CITY OF PORTLAND

has permission to Multi-unit condo #501- adding extra bedroom & bath app.280 sq ft

AT 99 SILVER ST #501 CBL 029 0001501

Permit No: 08-1316	Issue Date: 11/17/08	CBL: 029 0001501
-----------------------	-------------------------	---------------------

Tilt-Wash Double-Hung Windows

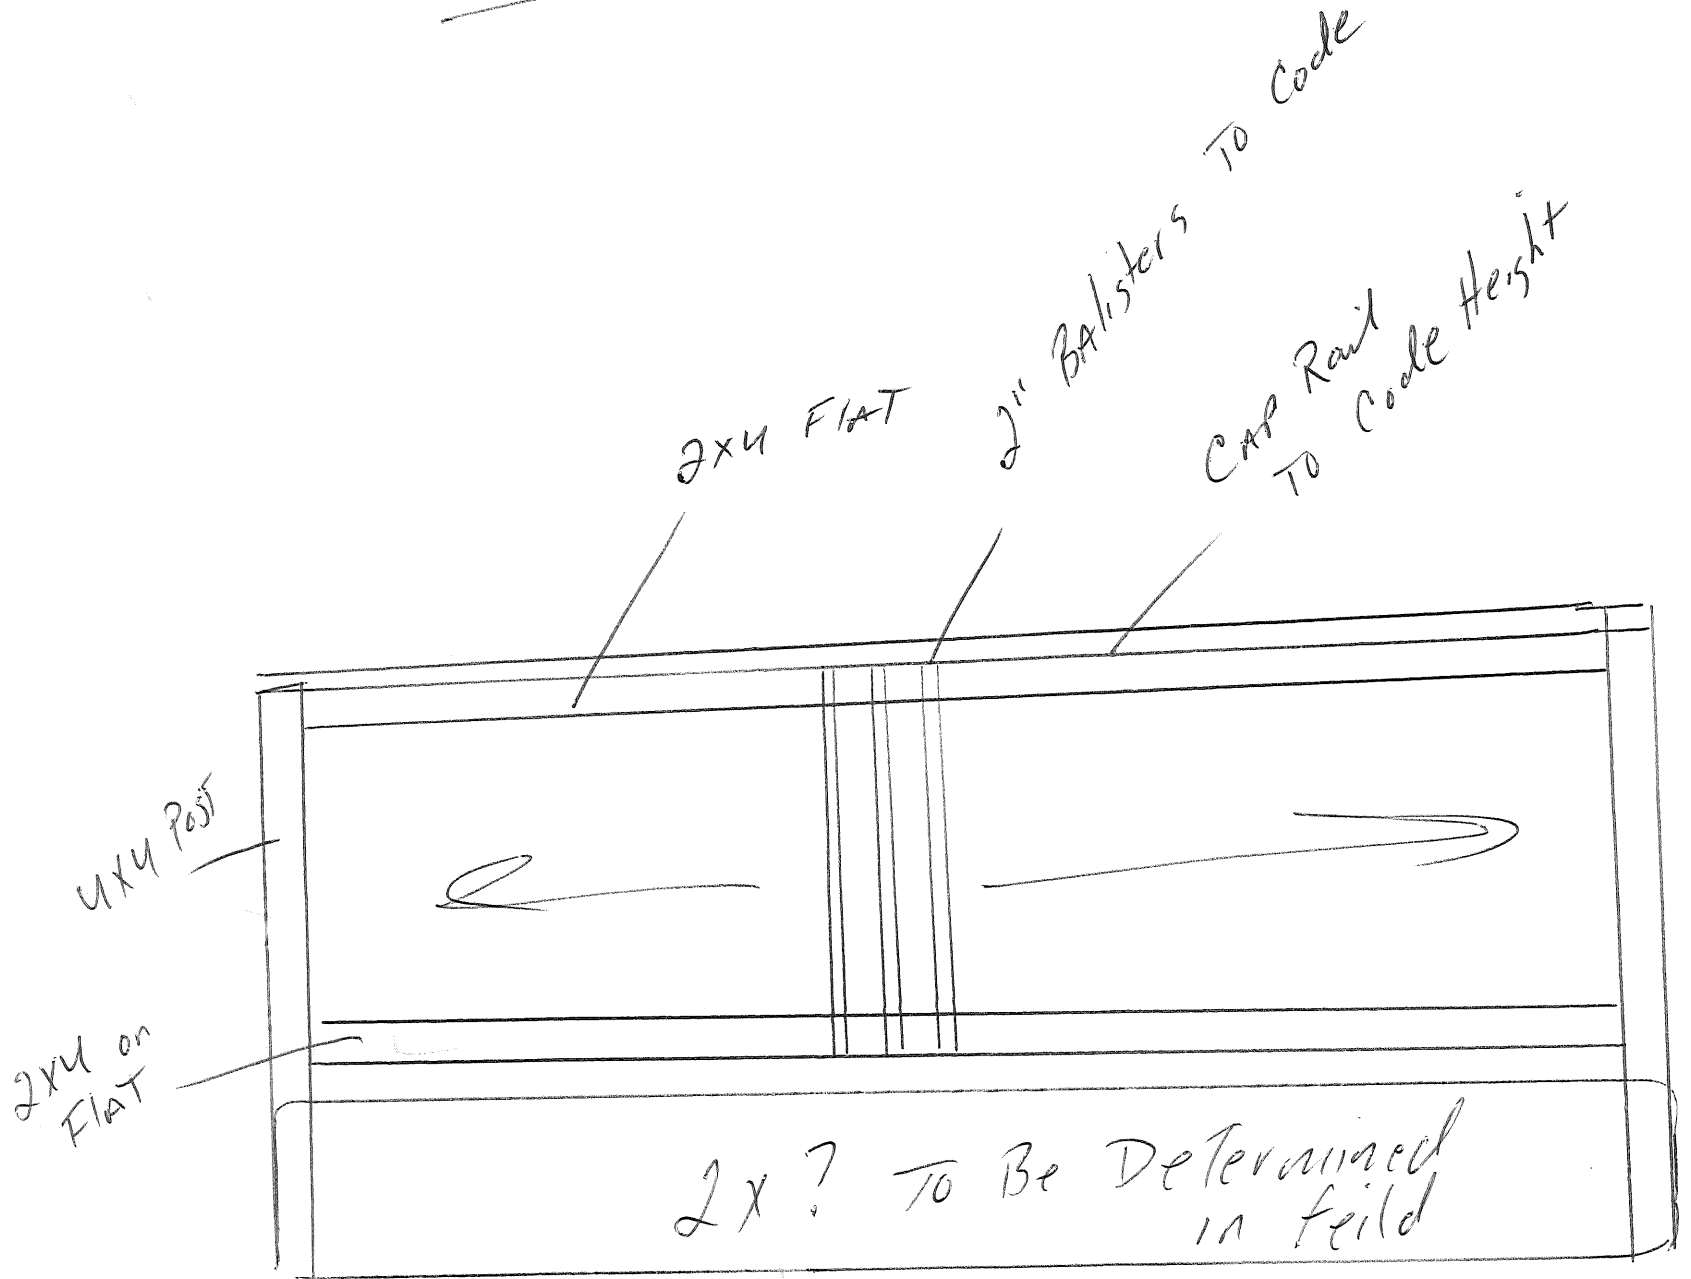
Change to overside EGRESS window
